**NPDES PERMIT FACT SHEET
INDIVIDUAL SEWAGE**

Application No. PA0085022 A-1
 APS ID 731
 Authorization ID 1442781

Applicant Name	<u>Conoy Township</u>	Facility Name	<u>Falmouth STP</u>
Applicant Address	<u>211 Falmouth Road</u> <u>Bainbridge, PA 17502</u>	Facility Address	<u>2515 River Road</u> <u>Bainbridge, PA 17502</u>
Applicant Contact	<u>Jennifer Rabuck</u>	Facility Contact	<u>Jennifer Rabuck</u>
Applicant Phone	<u>(717) 367-4991</u>	Facility Phone	<u>(717) 367-4991</u>
Client ID	<u>77263</u>	Site ID	<u>239234</u>
Ch 94 Load Status	<u>Existing Organic Overload</u>	Municipality	<u>Conoy Township</u>
Connection Status	<u>No Limitations</u>	County	<u>Lancaster</u>
Date Application Received	<u>June 5, 2023</u>	EPA Waived?	<u>Yes</u>
Date Application Accepted	<u>June 28, 2023</u>	If No, Reason	<u></u>
Purpose of Application	<u>NPDES Amendment</u>

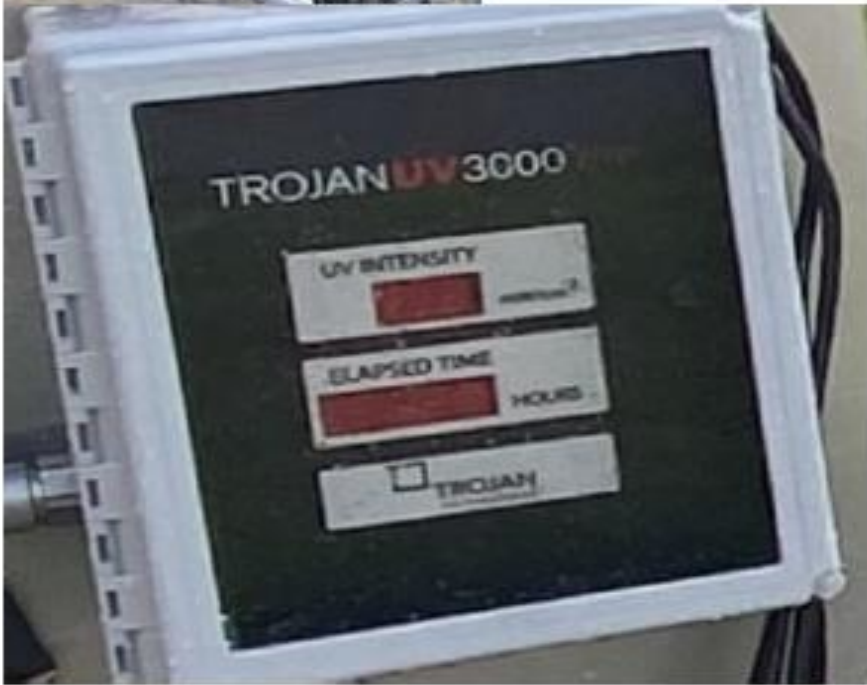
Good question. The UV units have intensity monitoring in mW/cm². See below snip for product data submitted with the Water Quality Management permit application, and photos showing the monitoring panels that were installed. Thanks for confirming!

The NPDES Permit will be amended to remove the TRC limit. In its place, a UV monitoring requirement will be added. Based on an email conversation with Conoy Township and Entech Engineering dated August 2, 2023, it has been confirmed that the UV system is capable of intensity monitoring in mW/cm². Therefore, the amended permit will have a monitoring requirement for UV intensity with these units. The updated effluent limits and monitoring requirements are shown below.
